Project	IEEE 802.16 Broadband Wireless Access Working Group < http://ieee802.org/16 >	
Title	Comments on AWD Idle Mode	
Date Submitted	2009-07-06	
Source(s)	Yih-Guang Jan, Yang-Han Lee, Hsien-Wei Tseng, Ming-Hsueh Chuang, Jheng-Yao Lin Tamkang University (TKU)	yihjan@yahoo.com
	Youn-Tai Lee, Chun-Yen Hsu Institute for Information Industry (III)	lyt@nmi.iii.org.tw
	Shiann-Tsong Sheu National Central University (NCU)	stsheu@ce.ncu.edu.tw
	Whai-En Chen National Ilan University (NIU)	wechen@niu.edu.tw
Re:	802.16m amendment working document "Comments on AWD 15.2.17 Idle Mode"	
Abstract	Comments on AWD Idle Mode	
Purpose	To be discussed and adopted by TGM for the 802.16m AWD.	
Notice	<i>This document does not represent the agreed views of the IEEE 802.16 Working Group or any of its subgroups. It represents only the views of the participants listed in the "Source(s)" field above. It is offered as a basis for discussion. It is not binding on the contributor(s), who reserve(s) the right to add, amend or withdraw material contained herein.</i>

Comments on AWD Idle Mode

Figure 419—Procedures during Type I ABS initiates idle mode entry

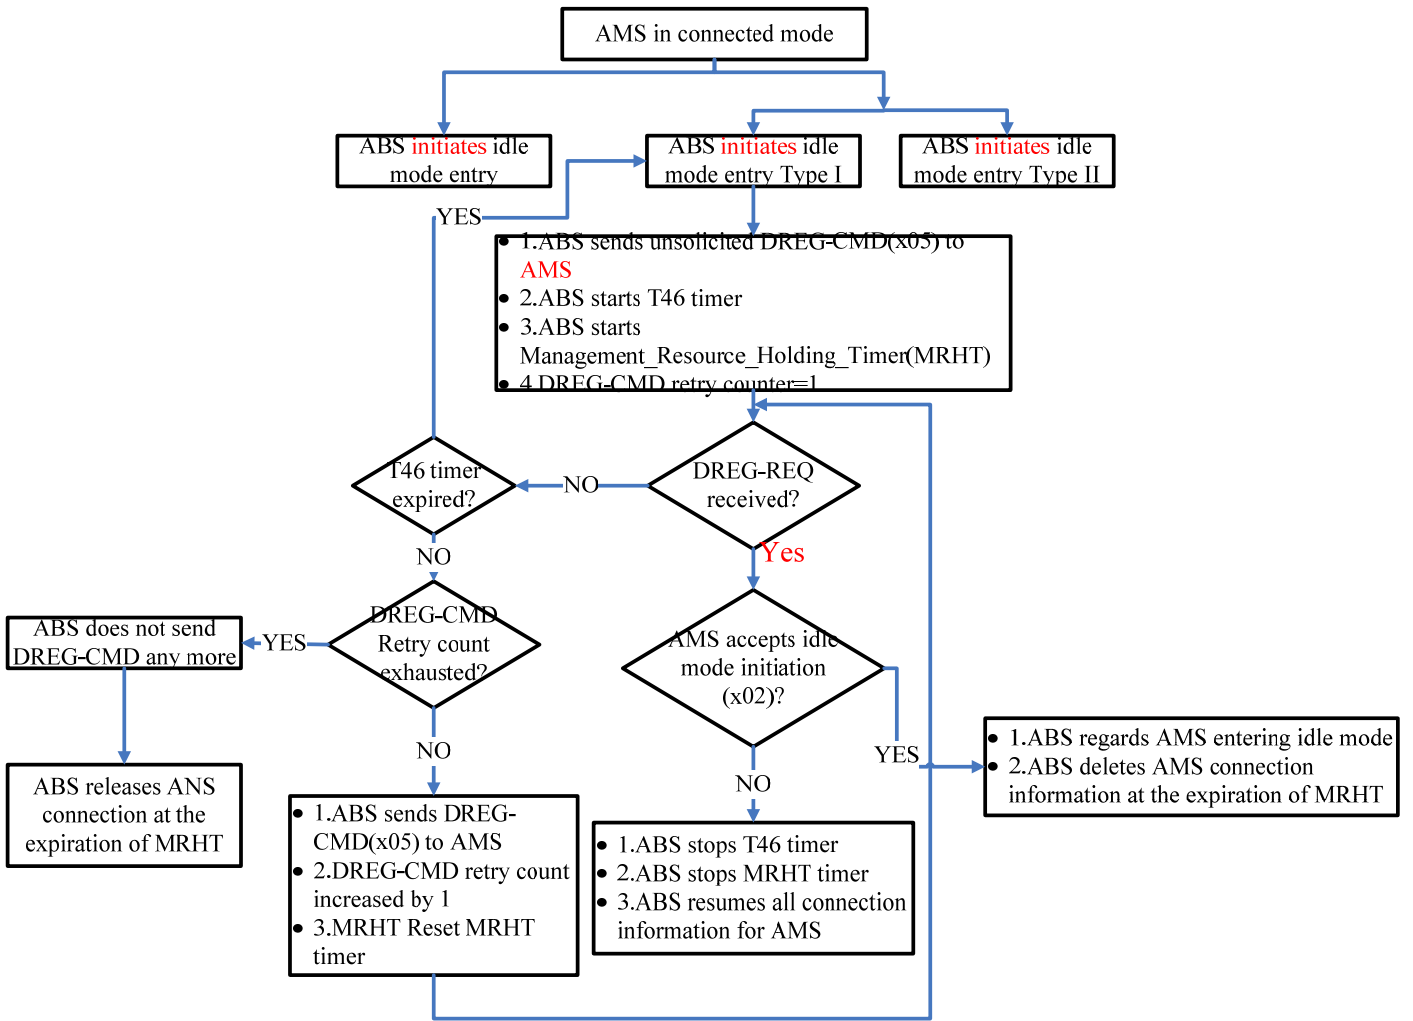
This contribution provides the corrected AWD text proposal to ABS initiates. In Figure 419, it has some errors in the functional blocks and needs correction.

[In IEEE 80216m-08_0010r2, Section 15.2.17.1.2, replace the original Figure 419 by the following modified figure.]
